Federal Specification for the Star-of-Life Ambulance
KKK-A-1822F
Dated 1 August 2007
Change Notice 7

THIS CHANGE NOTICE IS CUMULATIVE, AND INCORPORATES ALL CHANGES INCLUDED IN CHANGE NOTICES 1-6. IT SUPERCEDES NON-CUMULATIVE CHANGE NOTICES 1-6, AND SHALL BE RETAINED UNTIL SUCH TIME AS THE STANDARD IS REVISED.

The following changes, which form a part of FED-STD KKK-A-1822F, dated 1 August 2008, are approved by the General Services Administration, for use by all agencies.

Add FIGURE 6

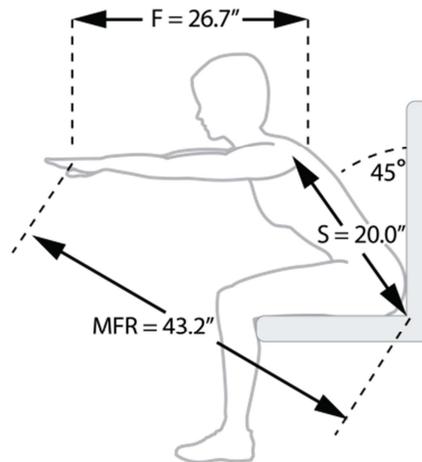
Seats and restraints should be designed to allow all EMSPs to reach patients with at least one hand at a maximum functional reach from a seated and restrained position. This includes a 5th female EMSP with a maximum functional reach of 43.2 inches as measured from the junction of the seat pan and seat back to the thumb tip of the arm fully extended parallel to the floor while leaning at a maximum 45° degree angle. (see figure 6)

Maximum Functional Reach Maximum functional reach is measured from the center point of the junction of the seat pan and seat back to the thumb tip where the arm is fully extended parallel to the floor and the torso is leaning forward at a 45° angle. Maximum functional reach is calculated using the following formula, where F = functional reach and S = seat to shoulder sitting height.

As an example using anthropometric data from MIL-STD-1472G, the maximum functional reach for a 5th percentile female, illustrated below is calculated using the seat (bottom of buttocks) to shoulder torso length (20.0 inches [508 mm]) leaned forward at a 45° degree angle and a functional reach as measured from the shoulder blade to thumbtip (26.7 inches [677 mm]) for a maximum functional reach of 43.2 inches (1097 mm).
